**PCN: V16-001-F48070-MA**

## Product Change Notice

Issue Date: 15 Apr 2016

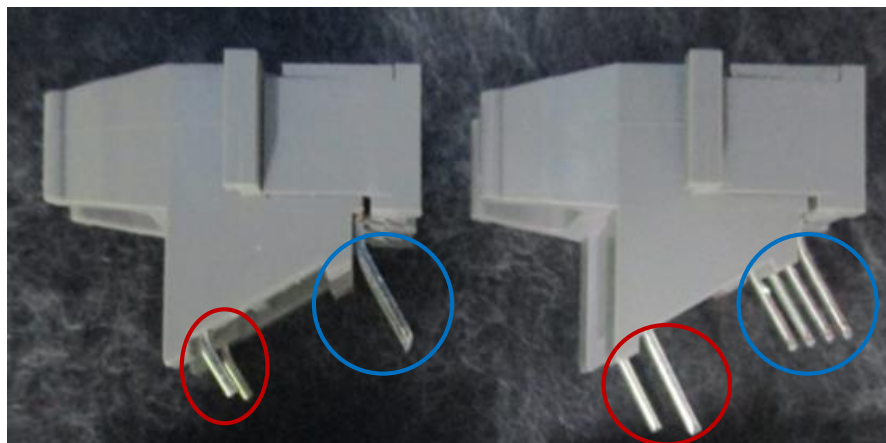
Increase the housing staple pin length from 2.8mm to 4.6mm, to be same as active pins.

Housing staple pins (pin5 and pin8 in red circle): Length increased from 2.8mm to 4.6mm.

Active pins (pin1 to pin4 in blue circle): No Change.

The base material and plating of staple pins remain unchanged.
